Design and Access Statement Addendum
MHE/OPA/11.1

Mill Hill East
Planning Application
August 2010

*This document is to be read in conjunction
with the October 2009 version.*

***The section in this addendum document replace
the commensurate sections in the original documents.***

Figure 3.6 Local connectivity diagram

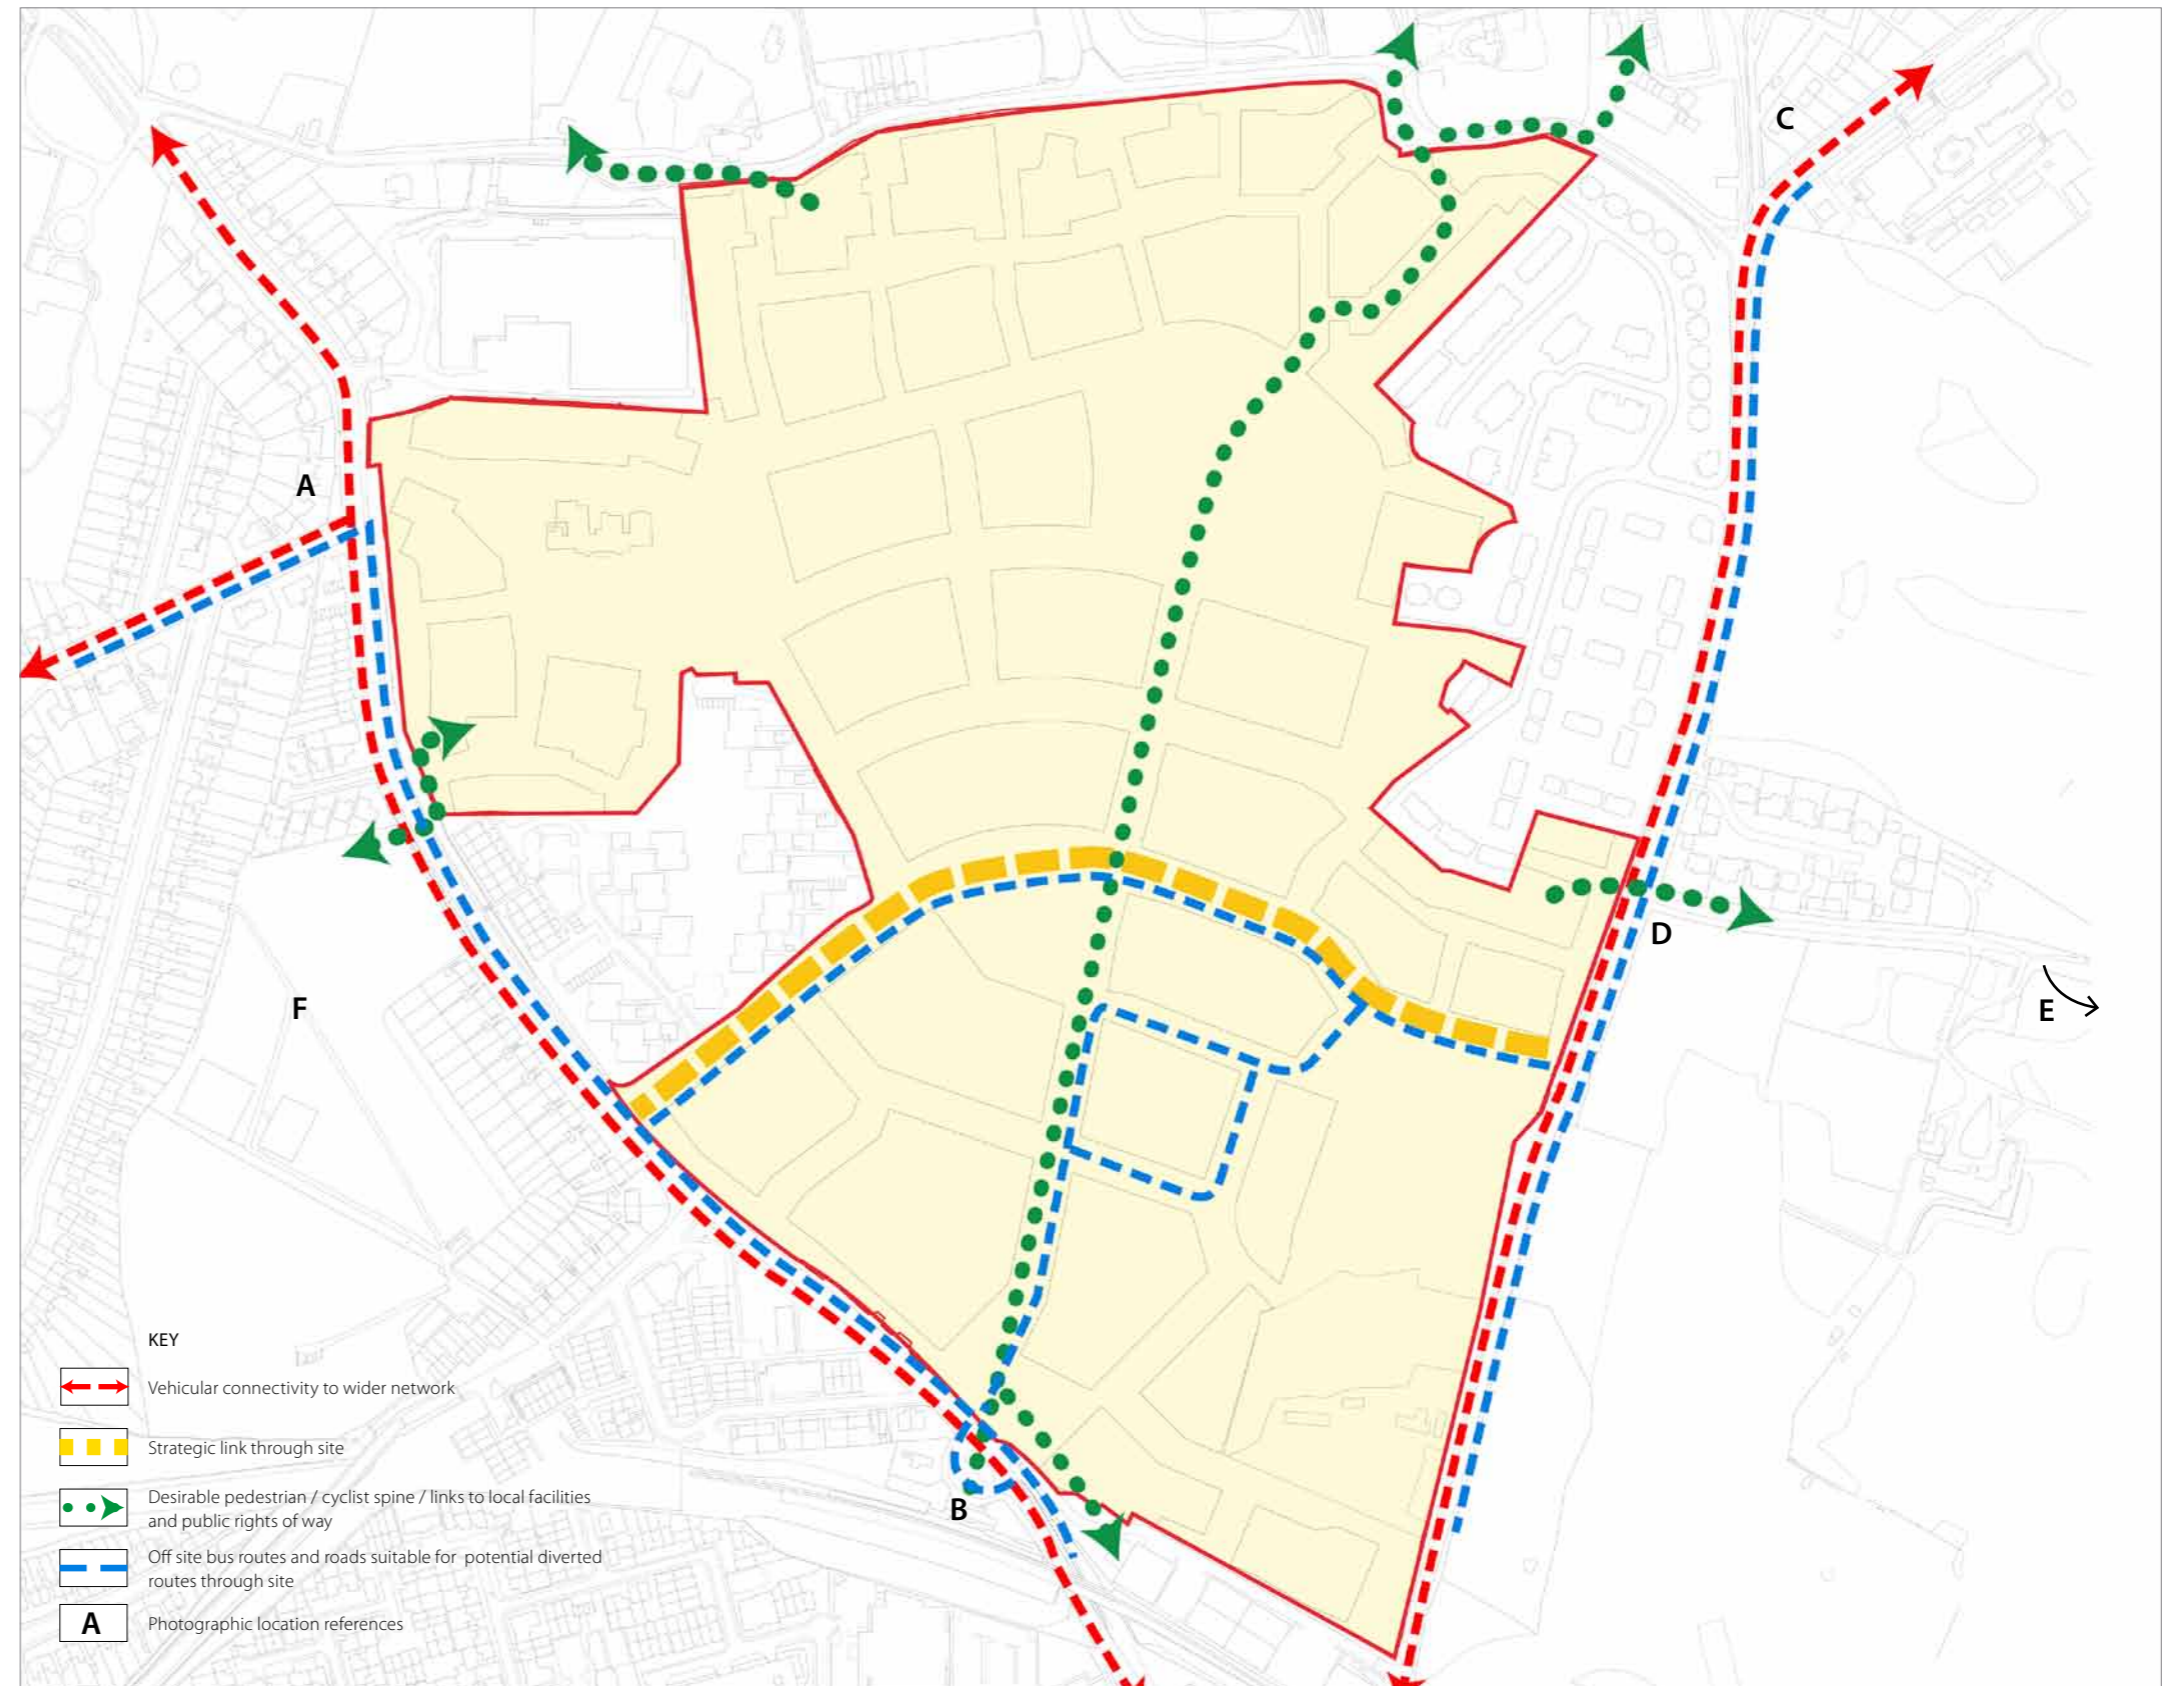
*Addendum note
Additional potential diverted bus routes
through site and key amended*

Figure 4.31 Accessibility strategy

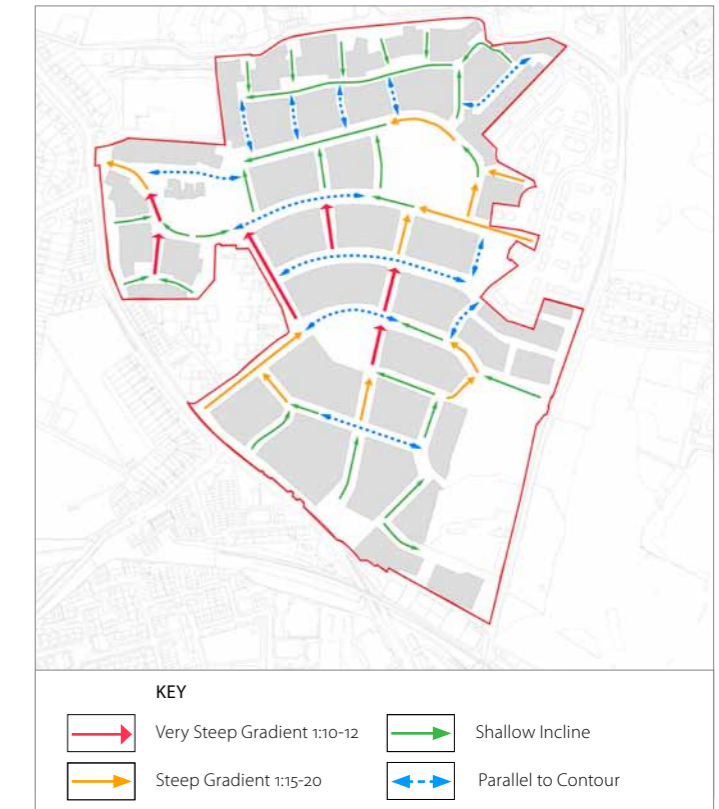
Addendum note
Minimum pavement width increased to 1800mm. This page should be read in conjunction with the separate Access Statement which has been submitted with the supplementary information.
